Request for Review

“Request for review for: "Integrated Energy Ltd. Grid Connected Electricity Generation Plant using Natural Gas" (1870)

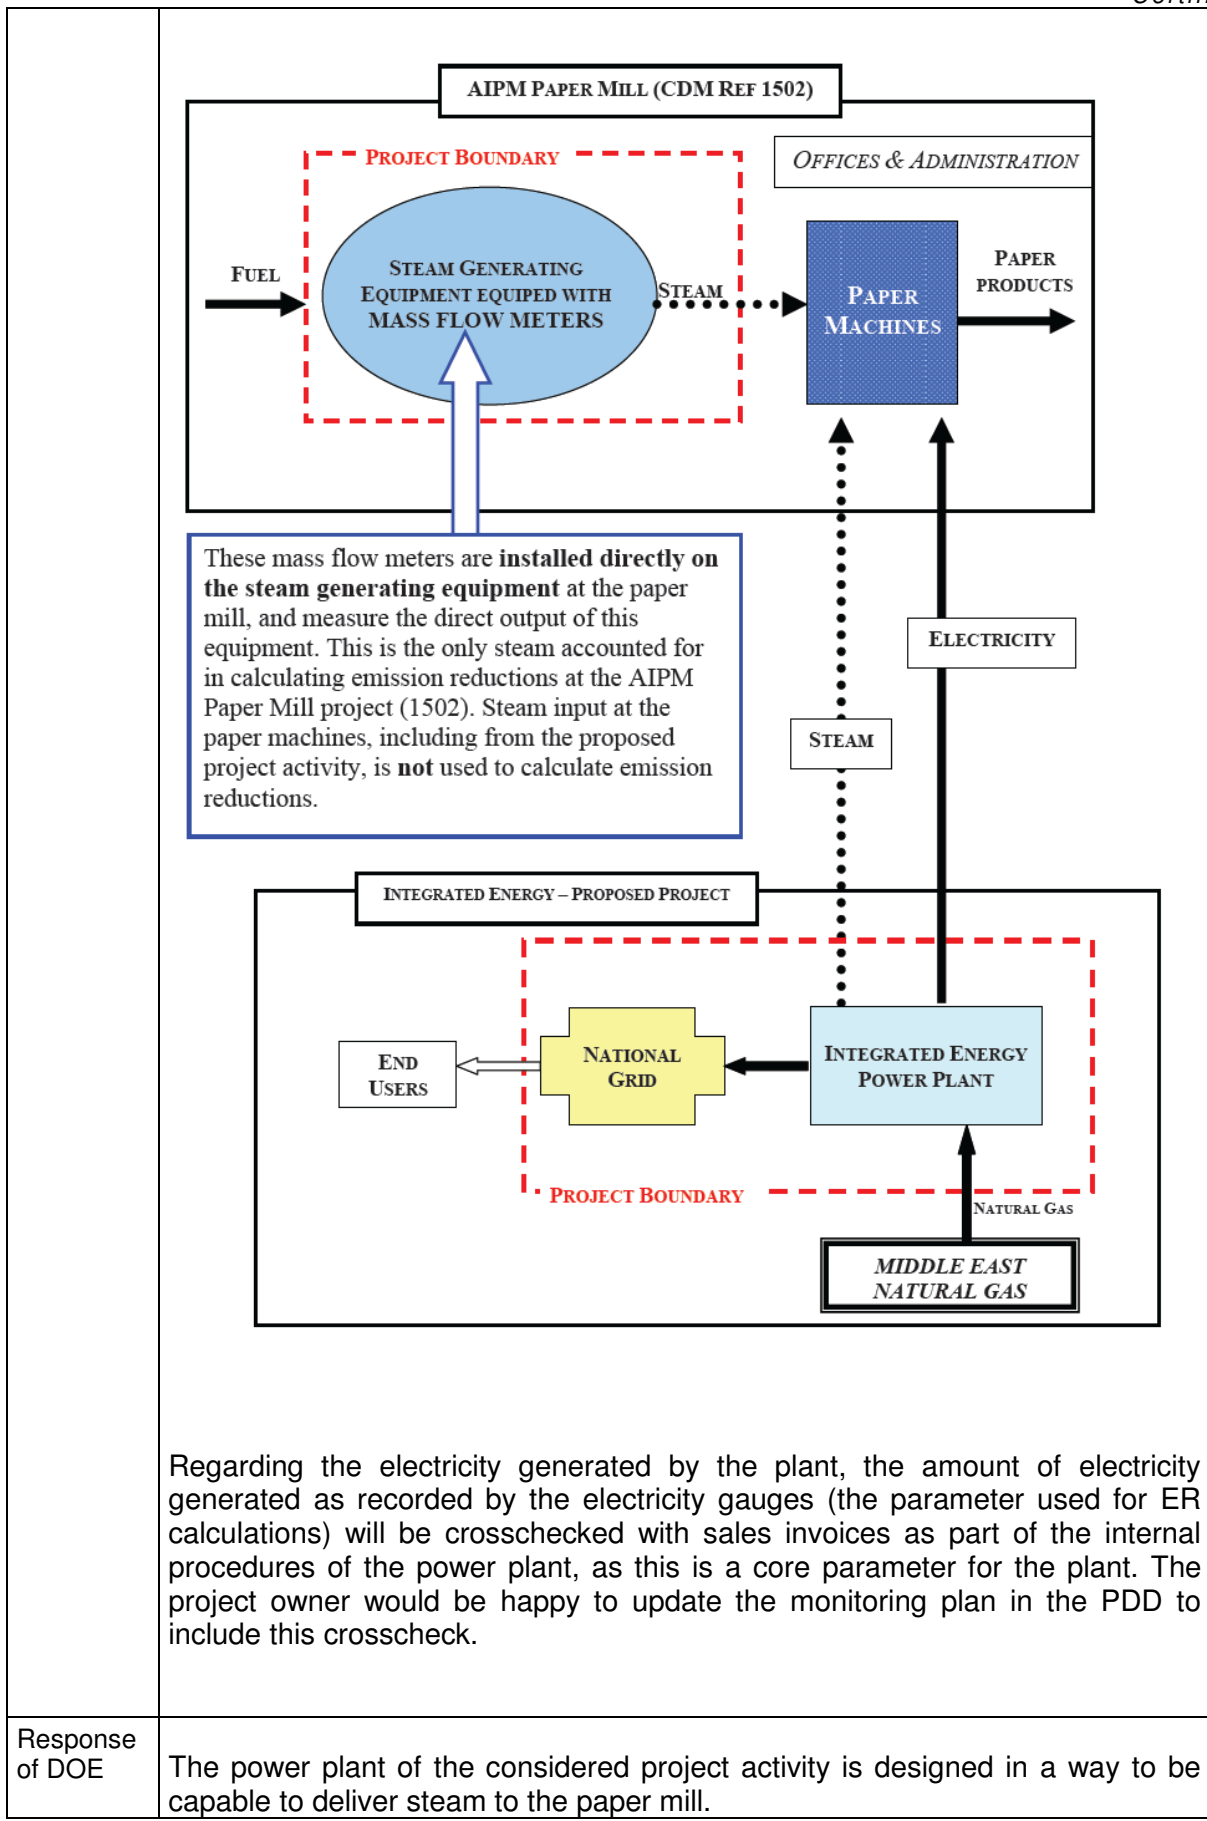
<p>Issue raised by EB Members / DNA</p>	<p><i>“The PP/DOE are required to further explain how the monitoring plan will ensure that the waste heat sold to the paper mill (CDM Ref 1502) will not be accounted for in the calculation of emission reductions. The electricity generation should be crosschecked with reliable evidences, such as sales invoices.”</i></p>
<p>Response of project participant</p>	<p>The EB's concern for potential double counting or false additions to the ERs claimed by either of the projects is certainly understood. However, in neither case is this possible.</p> <p>In the proposed power plant, emission reductions are claimed solely for the generation of electricity, and no reductions are claimed in any way for the steam generation. Steam generation is not a parameter in any of the equations, which allow the project to enjoy CERs based solely on the amount of electricity generated by the plant.</p> <p>Registered CDM project 1502 is a stand-alone, well-defined CDM project of its own. In this project, the project boundary is clearly defined as the existing boilers within the paper mill which are already supplying steam to the plant. Therefore, future steam generation at the power plant is clearly defined as being outside of the project boundary. At the paper mill, steam generation is measured by flow meters that are installed on each existing boiler. ER calculations are based entirely and solely on the steam generated in these boilers and recorded by these flow meters, in accordance with the approved and well-defined monitoring plan. ER calculations are not based on the amount of steam consumed by the plant, and therefore no emission reductions can be claimed for steam purchased from the proposed power plant project or any other external source for that matter. The approved monitoring plan for this project therefore provides full assurance that steam generated by the power plant will not be taken into account when calculating emission reductions.</p> <p>To further illustrate this point, please see the following diagram of the projects and the project boundaries:</p>

The power plant of the considered project activity is designed in a way to be capable to deliver steam to the paper mill.

At the paper mill itself a CDM project activity (American Israel Paper Mill (AIPM) Natural Gas Fuel Switch) has been carried out and registered on 25 April 2008.

The major parameter to calculate emission reductions achieved in this project activity is tons of steam produced in the project scenario in year y. In case the steam production would be measured not on each boiler but by joint meter(s) (e.g. at the entrance to production facilities) this could indeed lead to the case where steam from other sources could be also accounted for in the calculation of emission reductions.

According to the registered PDD the steam production is measured by steam meters mounted **on each boiler**. This has been positive validated by another DOE in course of validation. Bearing this in mind TÜV Nord is of an opinion that steam delivered from the power plant to the paper mill will be not accounted for calculation of emission reduction in another project activity.

With respect to the request regarding the crosscheck of the electricity generated by the plant with reliable evidences TÜV Nord and project participant agree to include a corresponding provision to the monitoring plan.
